Final Set, Jefferson Village Phase II  
(Bulletin 6)

JEFFERSON VILLAGE

TYPICAL PAVEMENT CROSS SECTIONS

HOR. SCALE: NO SCALE  
VER. SCALE: NO SCALE  
DATE: 3-27-00  
JOB NO.: DE99011  
FILE NO.: DE9911X1  
SHEET NO.: P-0.2

LEMAY AVE. STA. 278+00 TO STA. 286+00  
PAVING - PLAN & PROFILE

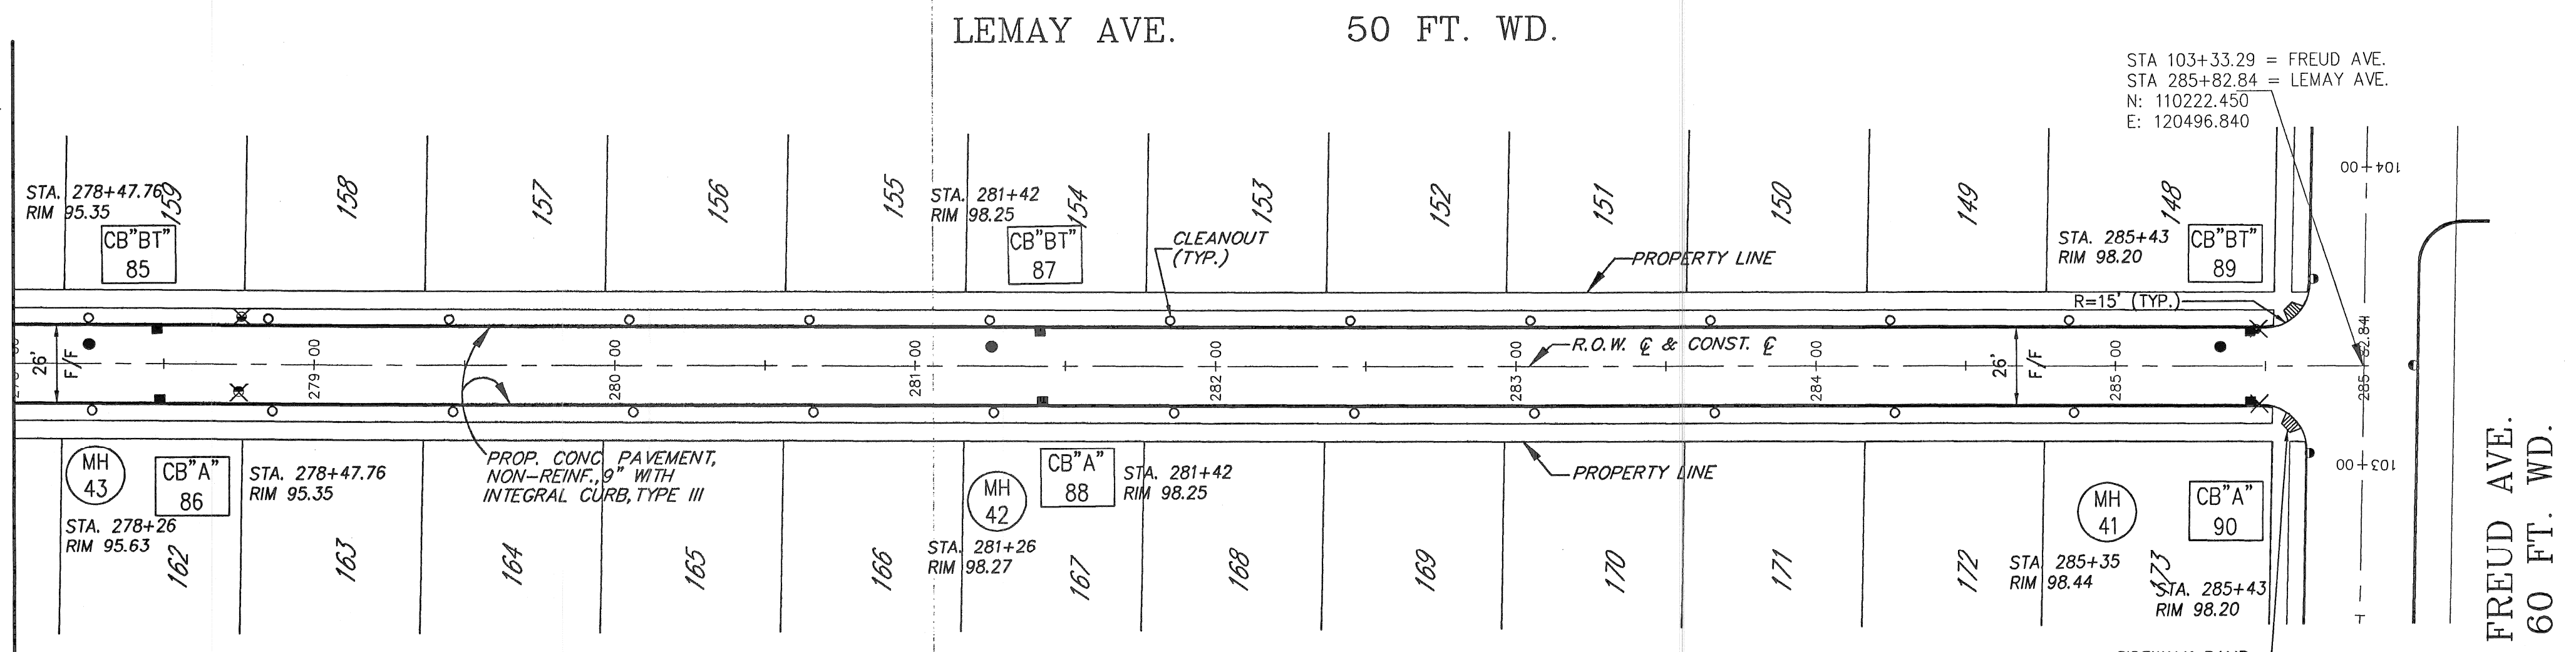
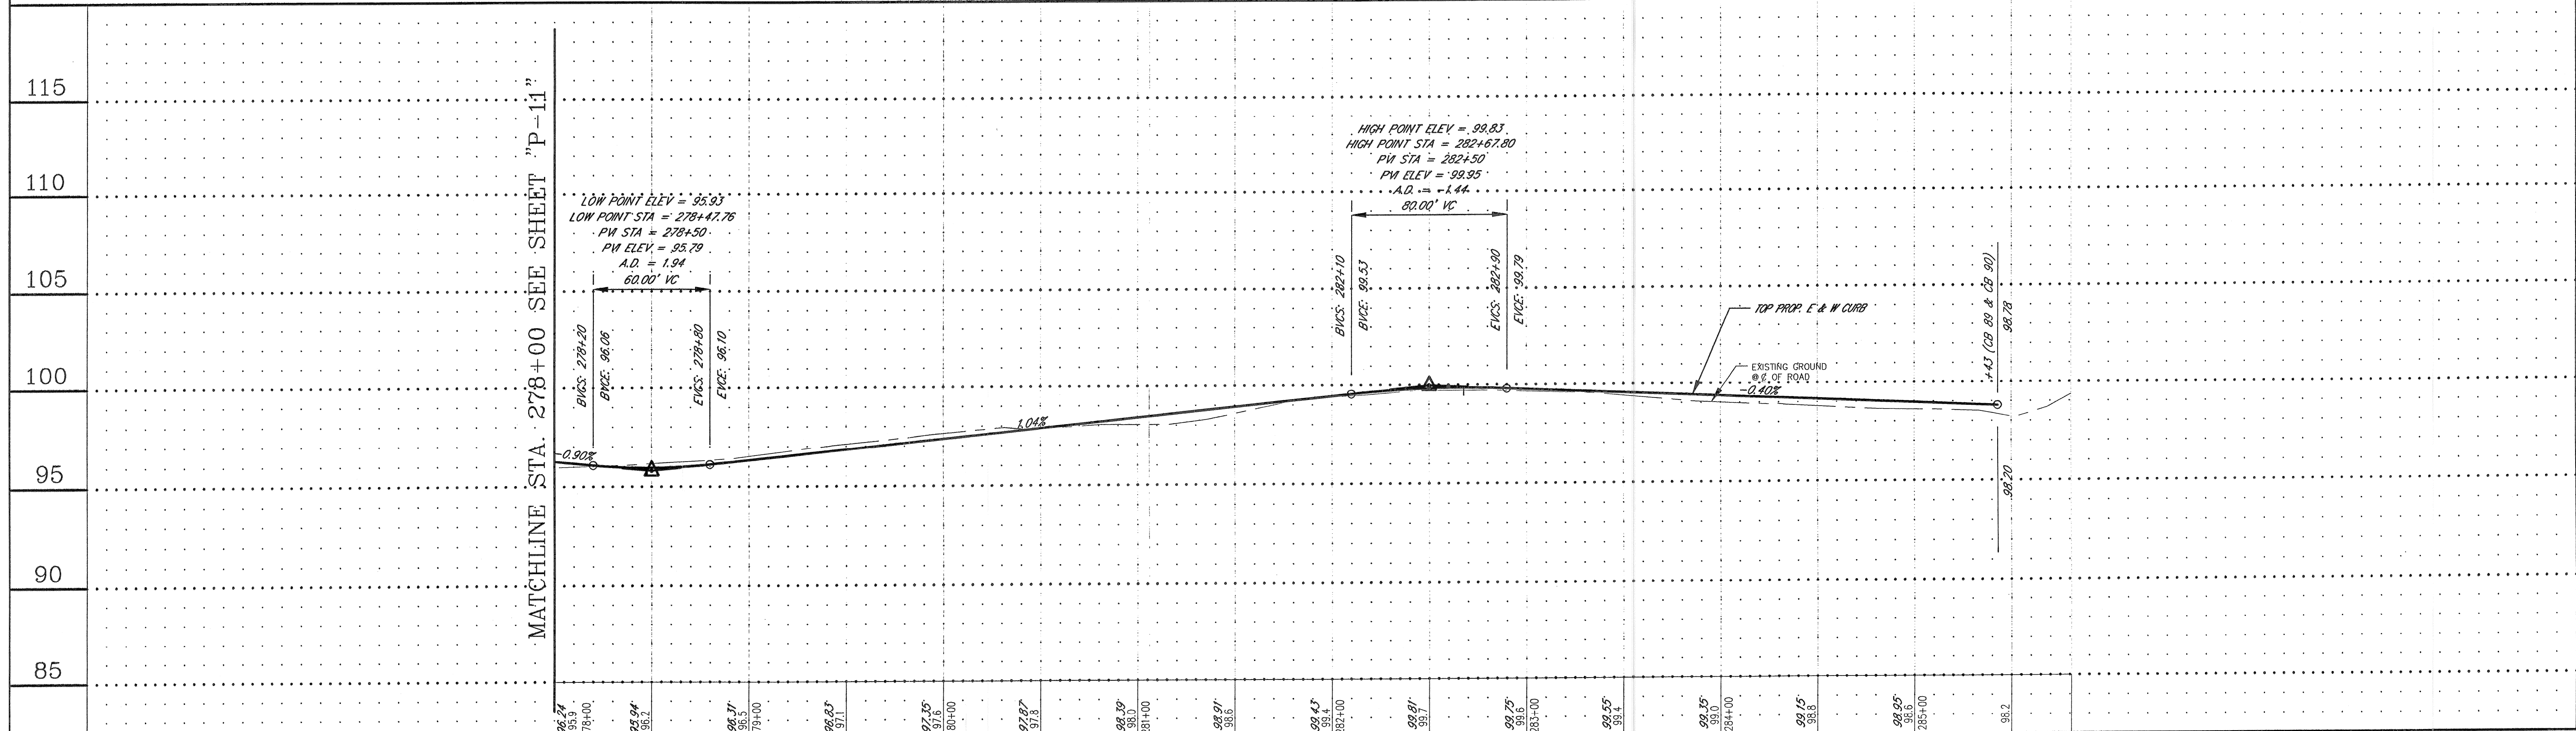
**NOTE:**  
 THE TYPE OF CURB WAS CHANGED FROM 7" HIGH STRAIGHT FACE TO 4" HIGH ROLLED CURB AFTER THE PREPARATION OF THE PAVING PLANS AND PROFILES (EXCEPTING FOR FREUD, MARQUETTE AND NEW STREET BETWEEN BENITEAU AND ST. JEAN). THE PAVEMENT ELEVATIONS AS SHOWN ON THE INTERSECTION DETAILS SHEETS SHALL BE MAINTAINED. ONLY THE TOP OF CURB ELEVATIONS SHALL BE DROPPED BY 0.25' (3"). THIS SHALL BE ACHIEVED BY SUBTRACTING 0.25' (3") FROM THE TOP OF CURB ELEVATIONS SHOWN ON THE PROFILES.

SEAL  
 JEFFERSON VILLAGE  
 Neighborhood Development Corporation  
 NEW STREET STA. 70+00 TO STA. 77+00  
 PAVING - PLAN & PROFILE

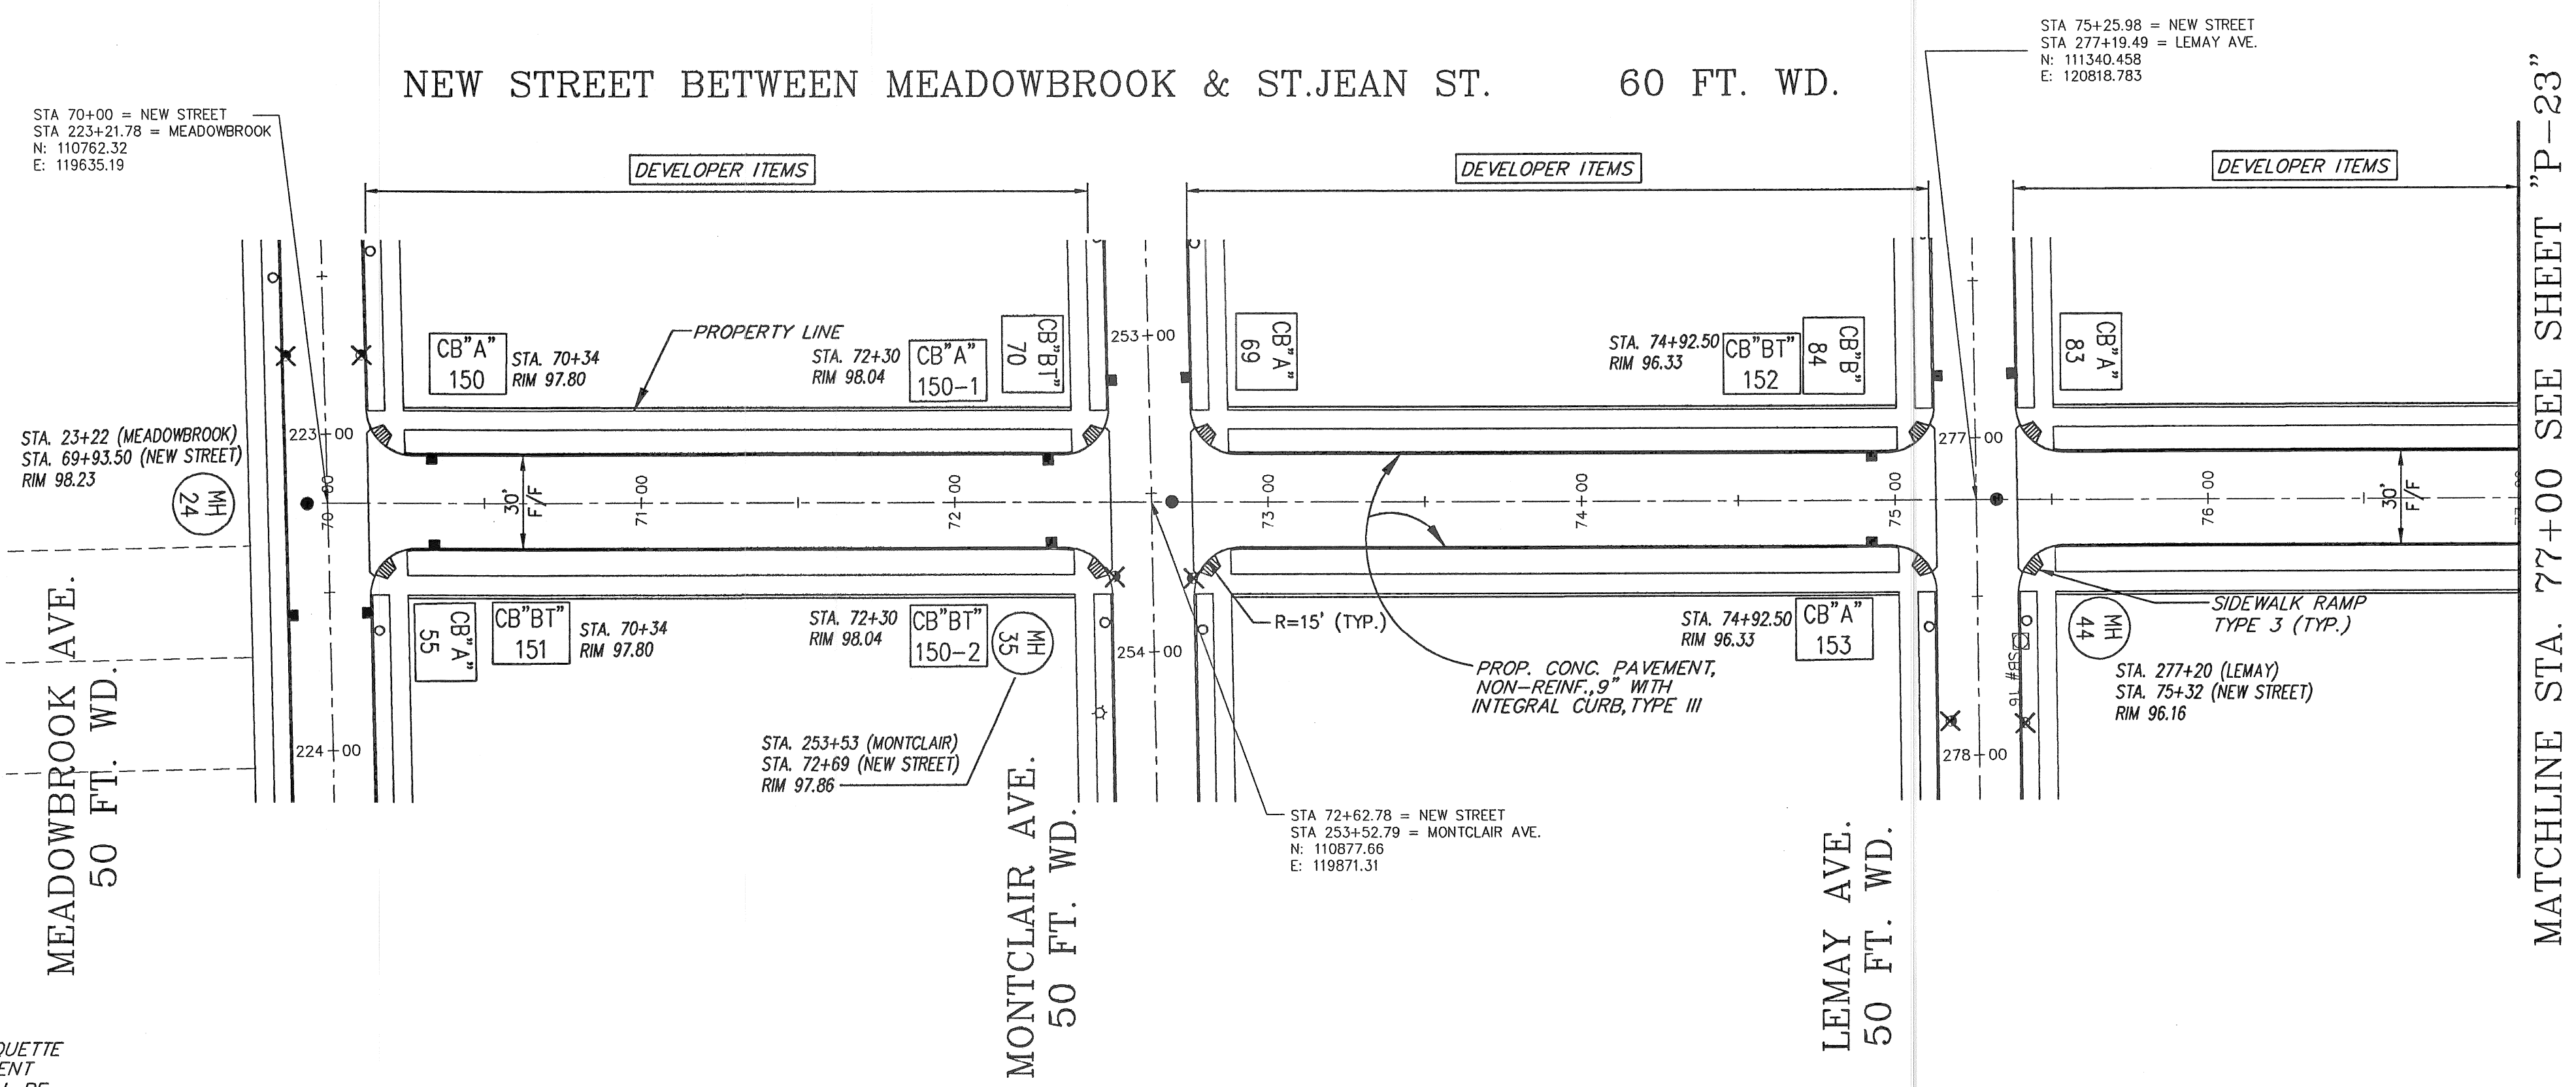
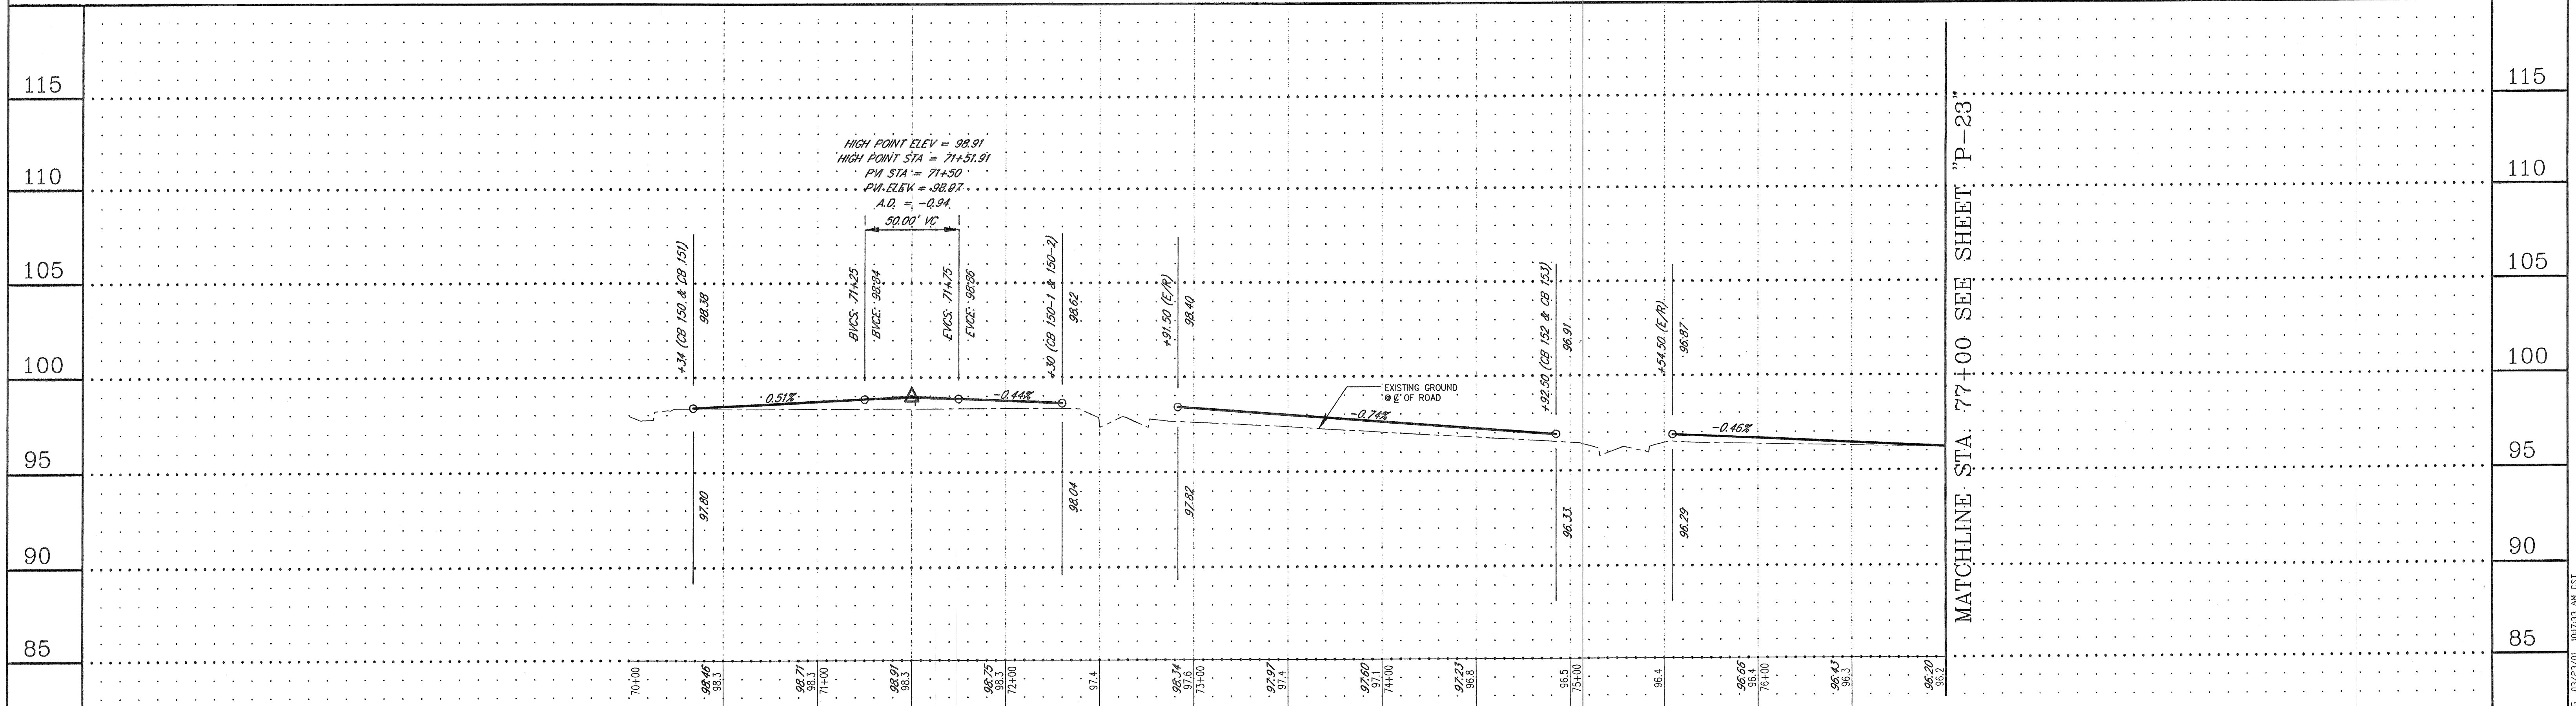
**NOTE:**  
 THE TYPE OF CURB WAS CHANGED FROM 7" HIGH STRAIGHT FACE TO 4" HIGH ROLLED CURB AFTER THE PREPARATION OF THE PAVING PLANS AND PROFILES (EXCEPTING FOR FREUD, MARQUETTE AND NEW STREET BETWEEN BENITEAU AND ST. JEAN). THE PAVEMENT ELEVATIONS AS SHOWN ON THE INTERSECTION DETAILS SHEETS SHALL BE MAINTAINED. ONLY THE TOP OF CURB ELEVATIONS SHALL BE DROPPED BY 0.25' (3"). THIS SHALL BE ACHIEVED BY SUBTRACTING 0.25' (3") FROM THE TOP OF CURB ELEVATIONS SHOWN ON THE PROFILES.
